**FINAL
MY2 (2023) MONITORING REPORT**

SWAMP GRAPE STREAM AND WETLAND MITIGATION SITE

Response to Monitoring Year 2 (2023) DMS Comments

DMS Comments Received (Black Text) & RS Responses (Blue Text)

FIGURE 1

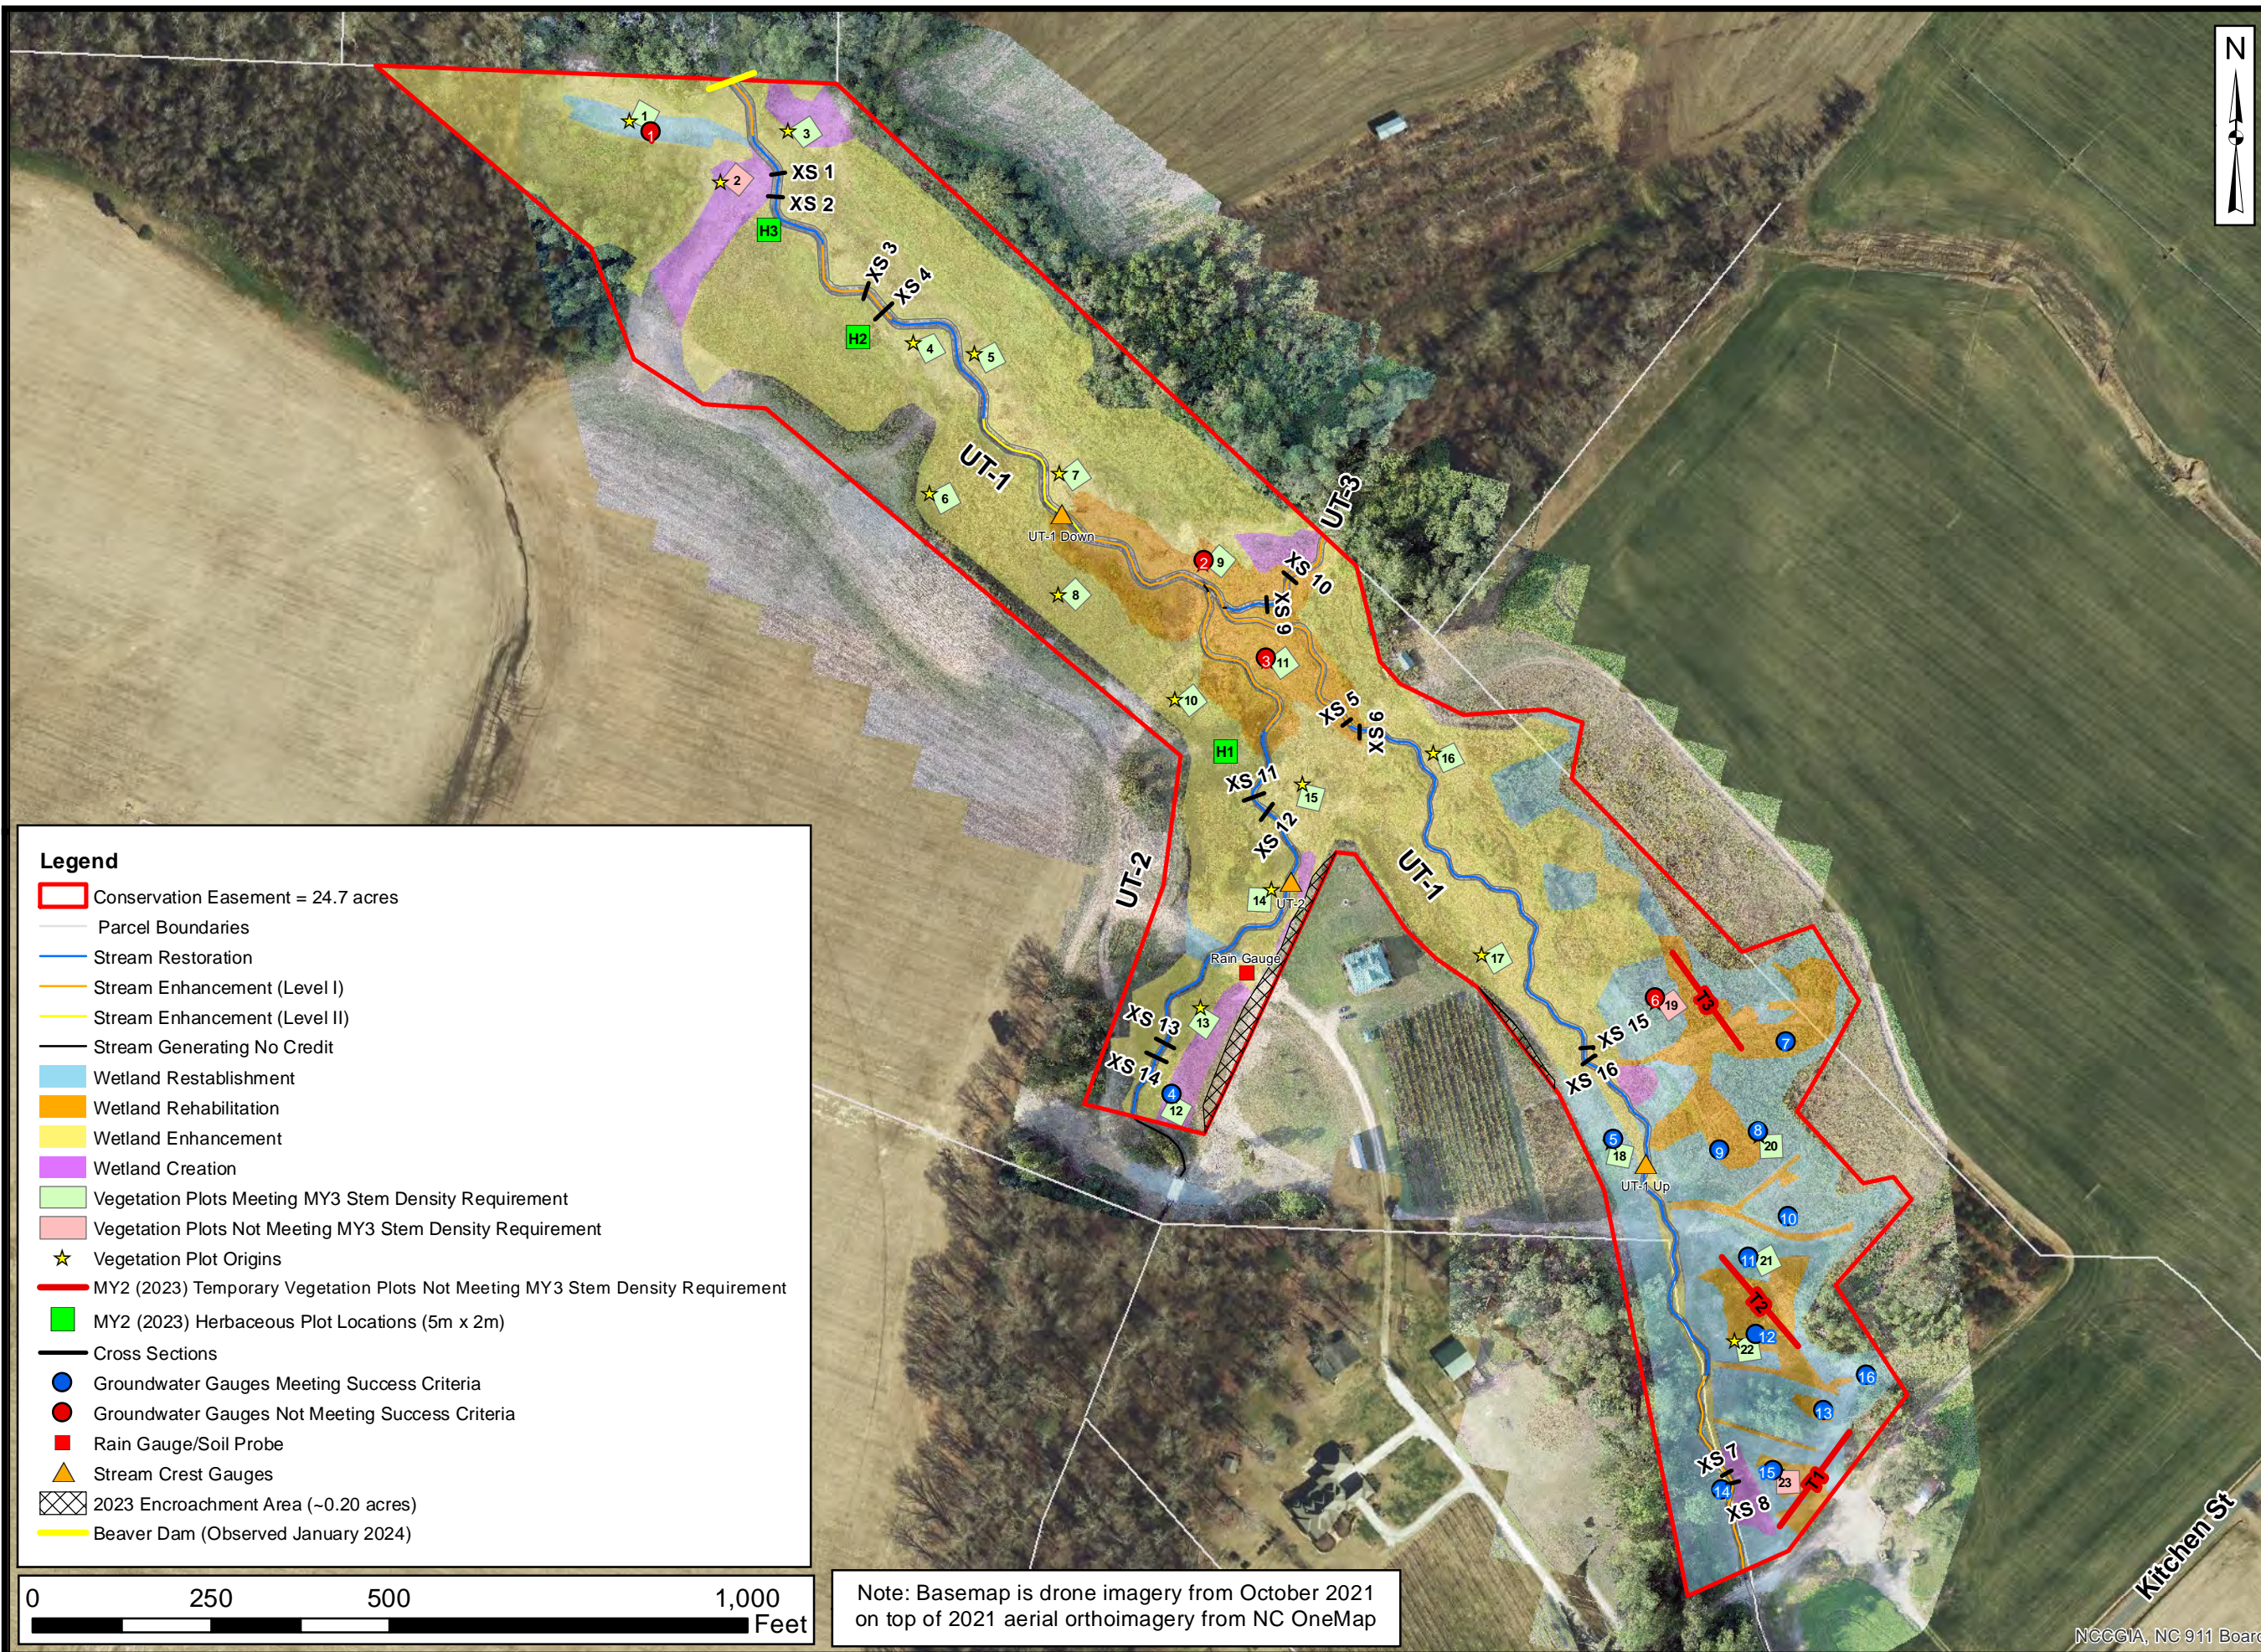
1. During site visit a newly created beaver dam was observed on UT-1, on the downstream stream enhancement II reach, upstream of the conservation easement boundary. Overall, the site looked great. [The location of the beaver dam was added to the report, CCPV, and digital submittal.](#)

FIGURE

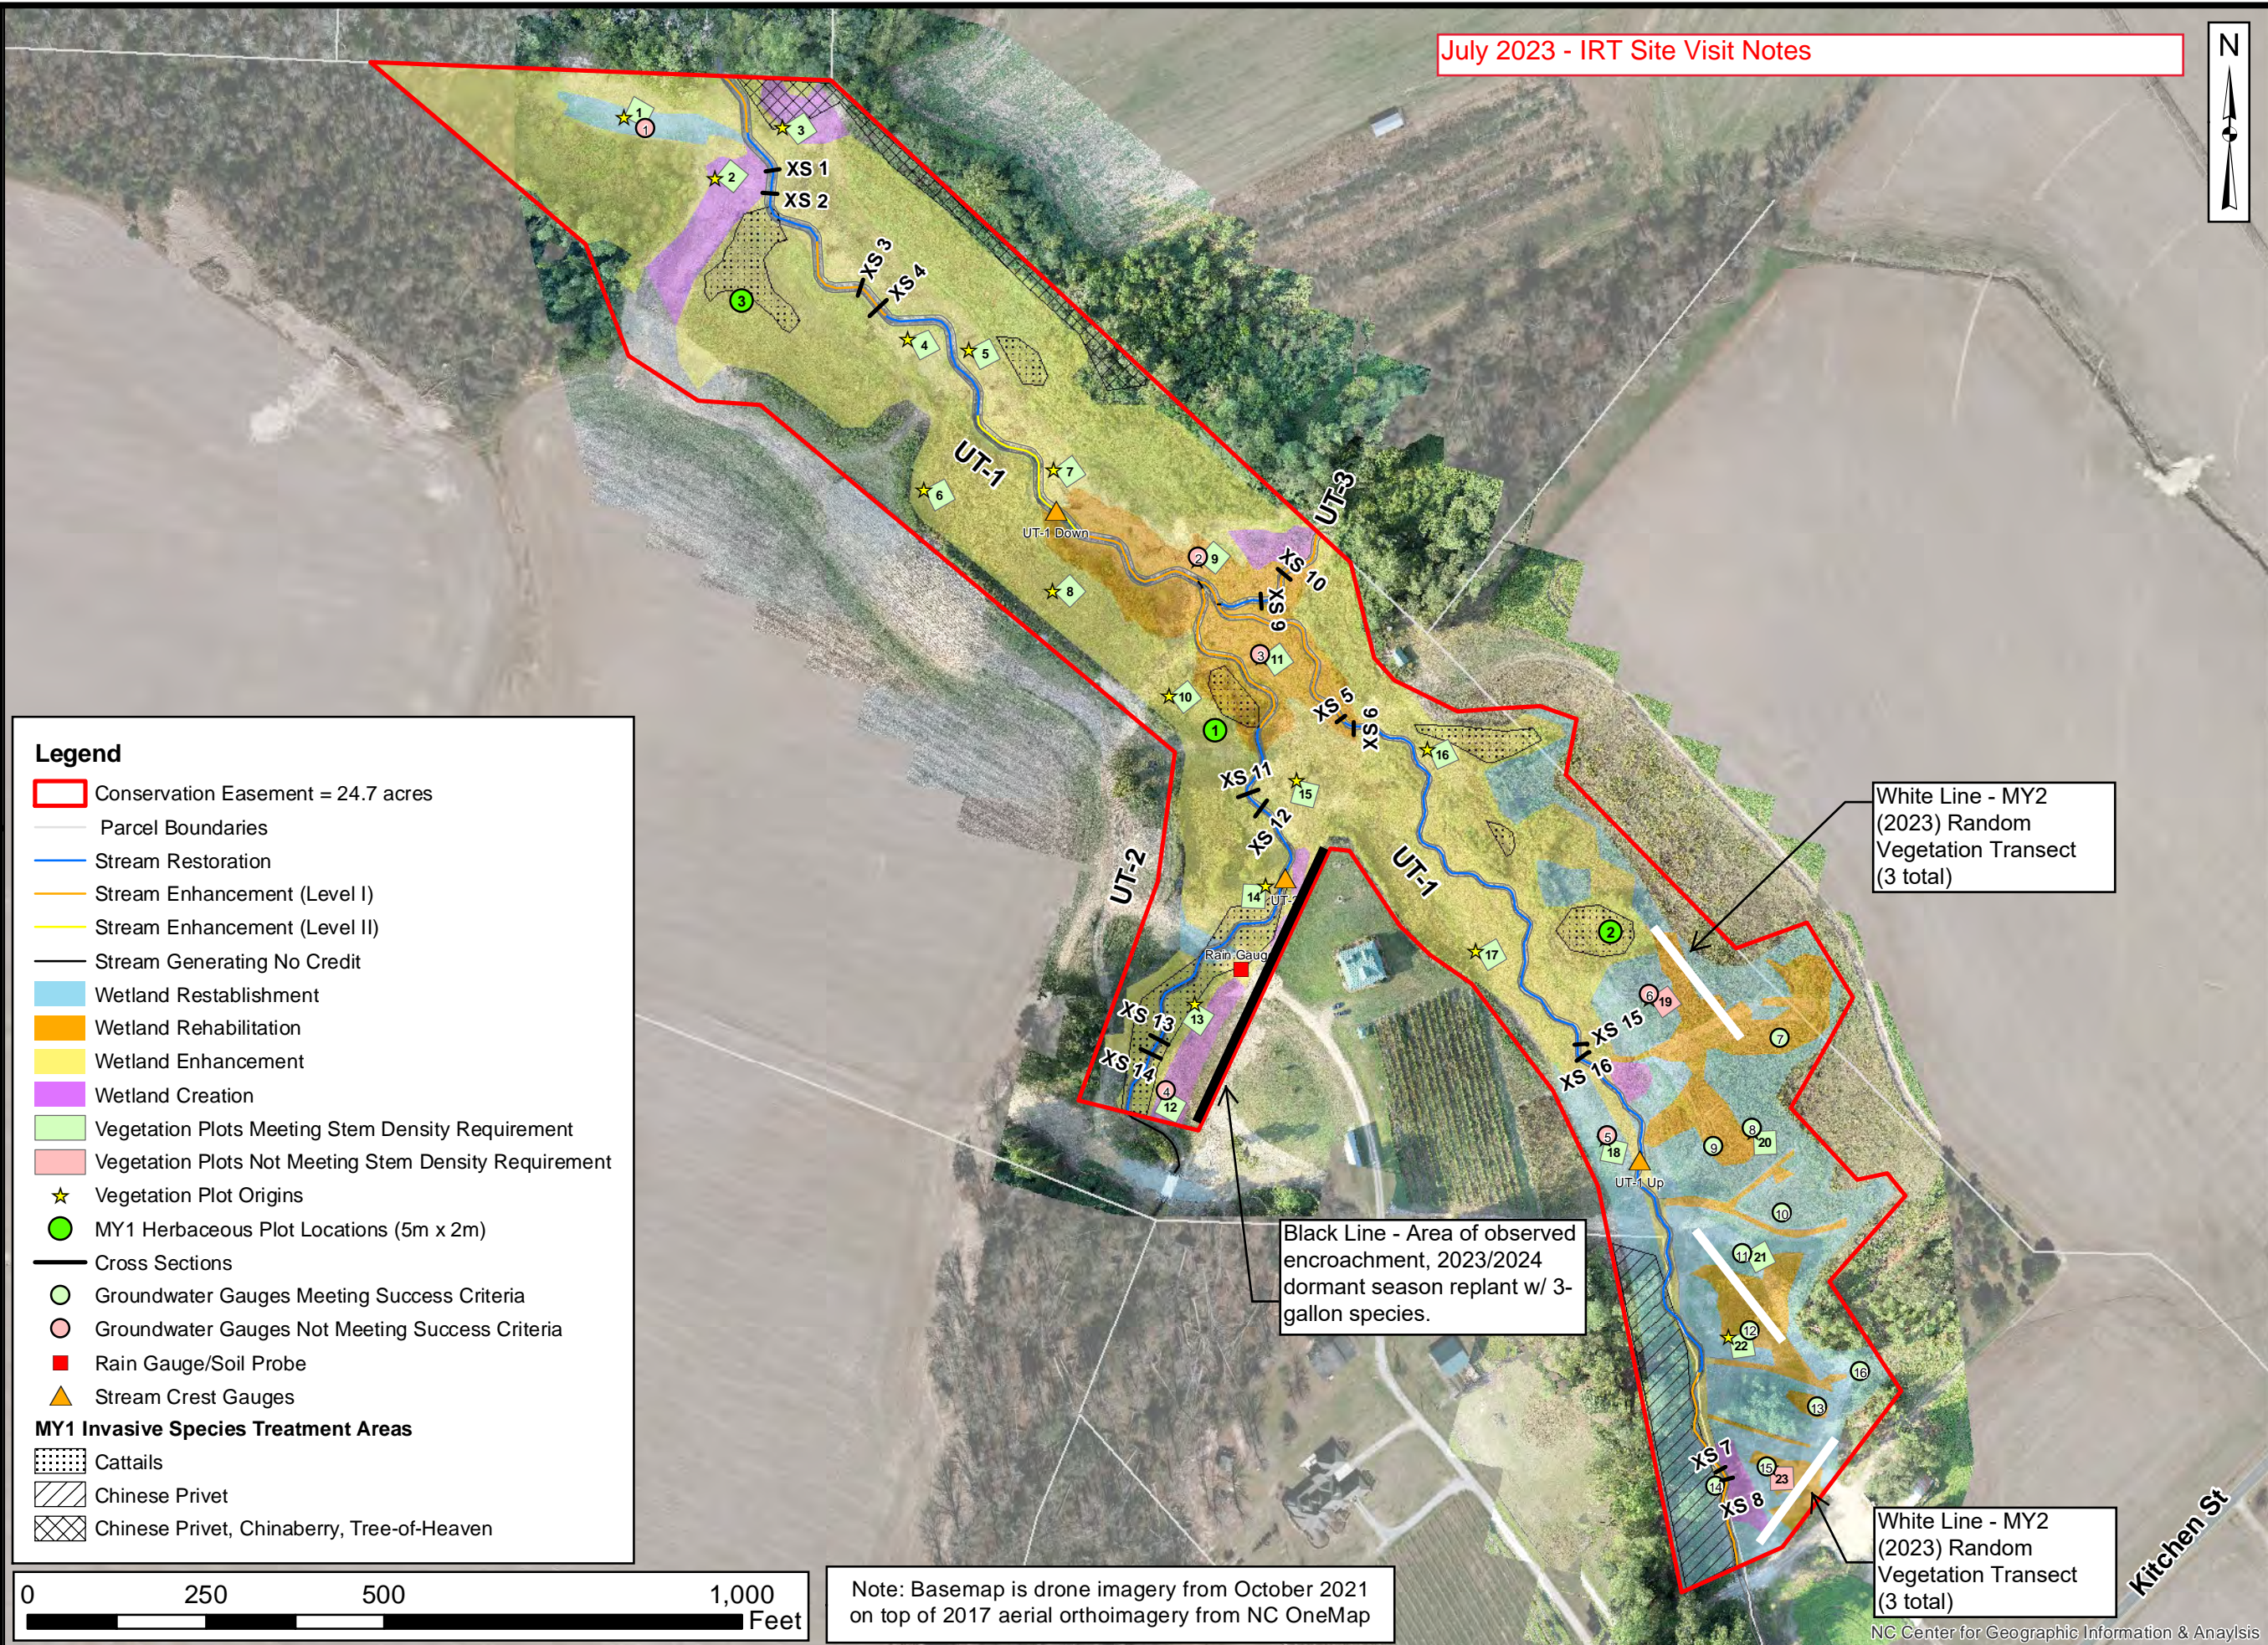
- RS and the IRT reviewed the observed area of encroachment along UT2’s right easement boundary (shown in the attached figure). RS will replant this area with 3-gallon upland containerized species from the approved Site Mitigation Plan during the dormant season of 2023/2024. The approved mitigation plan planting list is provided below for reference.
- RS will install additional treated fence post corners along this boundary line and add additional signage.

Black Line - Area of observed encroachment, 2023/2024 dormant season replant w/ 3-gallon species.
